Appendix 14.2

Quality Audit

Proposed RB Central Apartments Development, Sandyford, Dublin 18

IRES Residential Properties Limited

3.1.1 Pedestrian Crossing – Blackthorn Drive Entrance

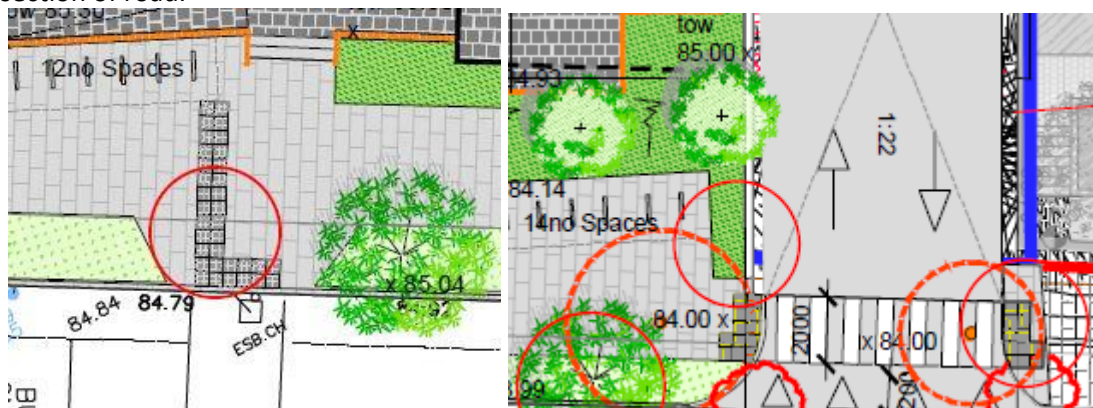
Issue: The existing pedestrian crossing at the existing entrance has zebra crossing markings in conjunction with tactile paving. The tactile paving is not the correct colour and no belisha beacons are provided which is normally required for such crossings in public places.

Hazard: Partially sighted pedestrians may be confused as to their priority for the crossing.

Recommendation: Remove the zebra crossing markings to ensure pedestrians do not incorrectly assume right of way to crossing. The lines surrounding the bar markings can remain.

To be completed by Designer					
Issue	Item Accepted		Recommended Measure Accepted		Describe Alternative Measure
	Yes	No	Yes	No	
3.1.1	x		x		Will show zebra markings to be removed.
3.1.2	x		x		1) Tactile to Carmanhall crossing will be changed to red. 2) Zebra markings to carpark ramp cross will be removed.
3.1.3	x		x		Tree will be removed
3.1.4	x		x		Will provide height details for low upstand wall and ensure planting is low level
3.1.5	x		x		
3.1.6	x		x		Cycle parking paving to match adjacent footpath paving
3.1.7	x		x		Cycle lane moved. Work in progress to move the columns.
3.1.8	x		x		Cycle lane moved. The car access is minimum 4.2m wide.
3.1.9	x		x		Work in progress.
3.1.10	x		x		Gate added.
3.1.11	x		x		Work in progress.
3.1.12	x		x		Plans updated.

3.1.3 Carmanhall Road – Car Park Exit – adjacent Landscaping

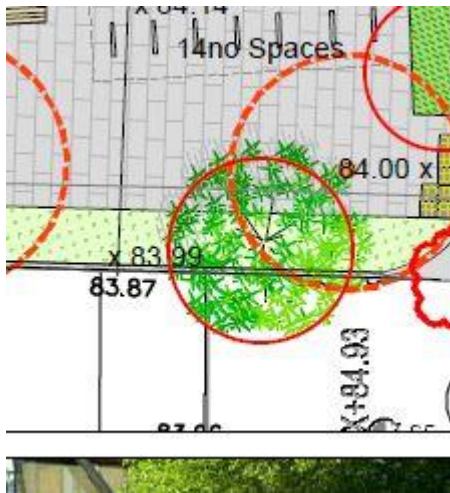
Issue: semi mature tree inside visibility splay for basement exit – girth will increase with growth impeding visibility to right.

Recommendation: Ensure that landscaping does not encroach into visibility splays

3.1.4 Carmanhall Road - Car Park Ramp Adjacent Retaining wall/Landscaping

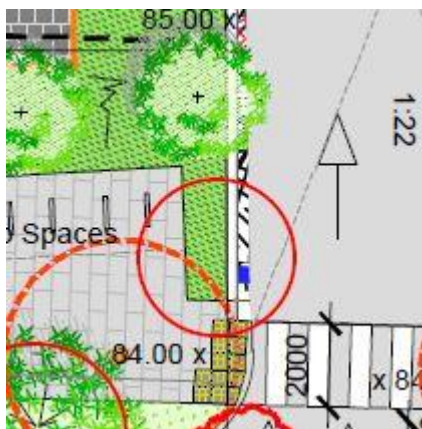
Issue: Planting and retaining wall adjacent to ramp potentially impeding visibility of pedestrians on path

Hazard: Exiting vehicles may collide with crossing pedestrians.

Recommendation: ensure low level planting provided and/or low upstand to wall to ensure that both horizontal and vertical visibility splays are accommodated.

3.1.5 Carmanhall Road – Car Park Access Ramp – splitter island

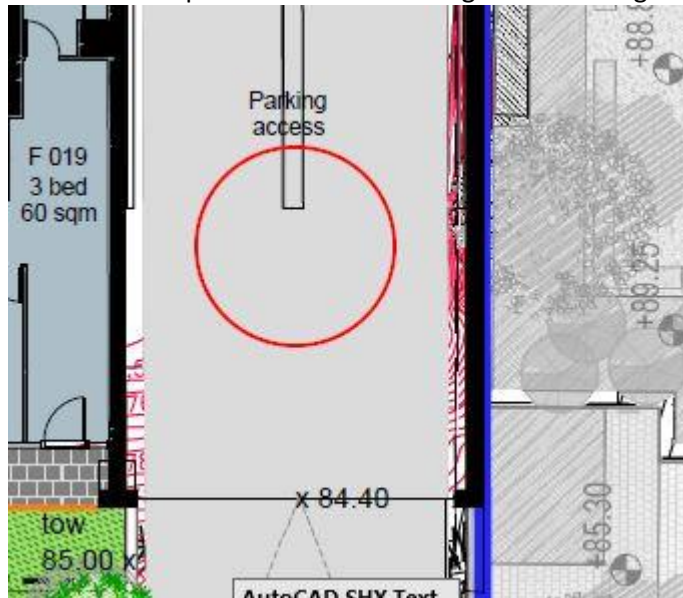
Issue: There is potential for drivers to go down wrong side of ramp, or over run same.

Recommendation: Provide appropriate retroreflective/signage to highlight hazard.

3.1.6 Courtyard Cycle Stands

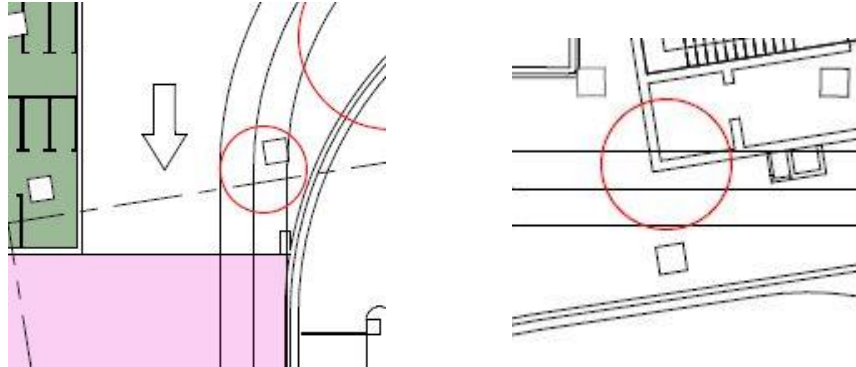
Issue: Finish at cycle stands is called up as compacted gravel. This is likely to erode over time leading to ponding/trip hazards.

Recommendation: Use robust paving finish

3.1.8 Walls adjacent Cycle Track

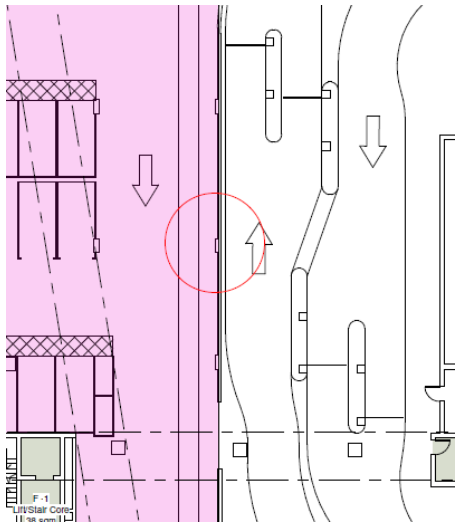
Issue: Structural walls located in close proximity to cycle access routes.

Recommendation: Offset cycle track to ensure there are not hazards adjacent, but also ensuring sufficient space for vehicles to pass. Checks should also be made for vertical clearances – and where insufficient cyclists should also be advised to dismount where headroom within the basement is less than 2.40m.

3.1.9 Car Park Access Ramp

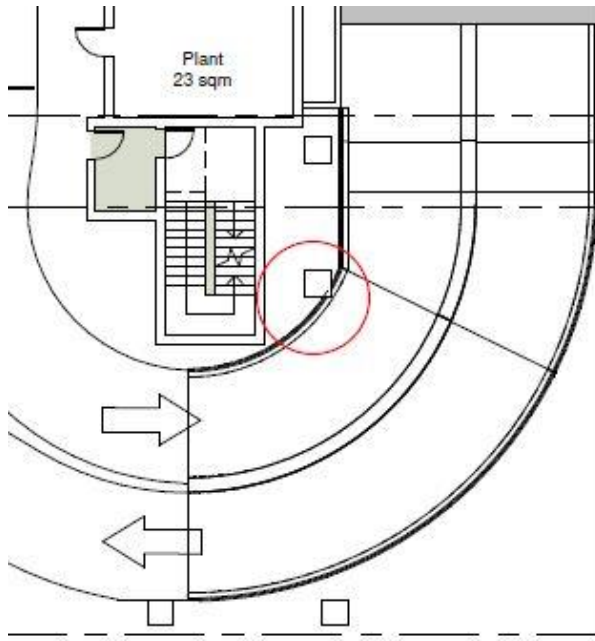
Issue: A column encroaches into ramp rubbing strip which is likely to be hazardous to approaching traffic.

Recommendation: ensure columns are located outside rubbing strips

3.1.10 Demarcation between Car Park Access Ramps

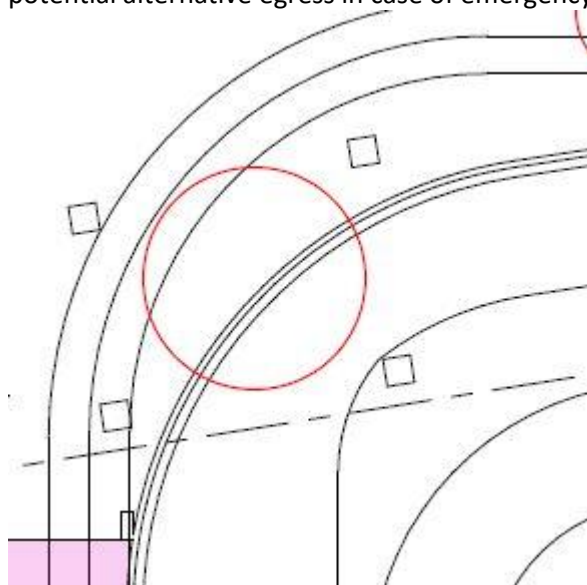
Issue: A solid separation between accesses to Carmanhall Road and Blackthorn Drive which prevents potential alternative egress in case of emergency.

Recommendation: provide removable/openable section in wall.

3.1.11 Columns on Car Park access Routes

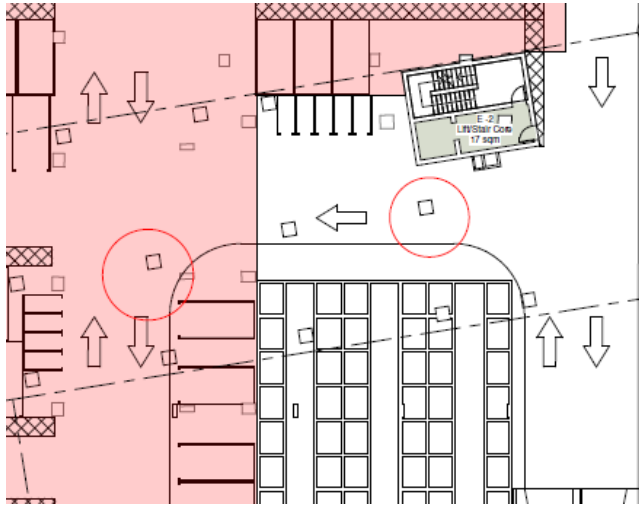
Issue: Columns obstructing car access routes

Recommendation: relocate or remove columns to ensure that access widths comply with IStructE Multi storey car park guidelines.

3.1.12 Car Park – Vehicle routing

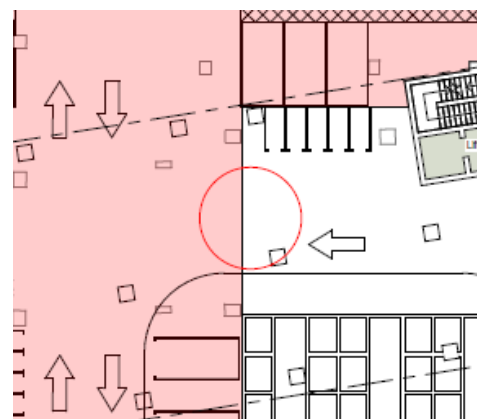
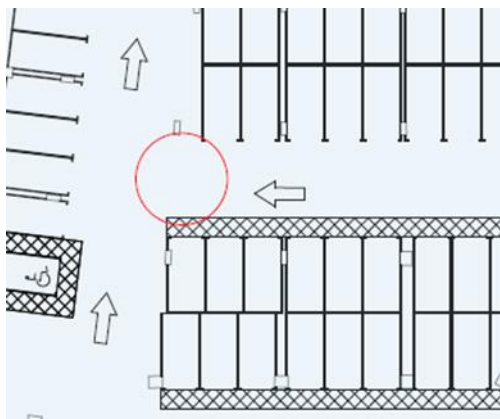
Issue: There is no instruction to drivers of no entry to one way aisles where they are one way.

Recommendation: ensure 'no entry' markings and overhead signs are provided to aid wayfinding.
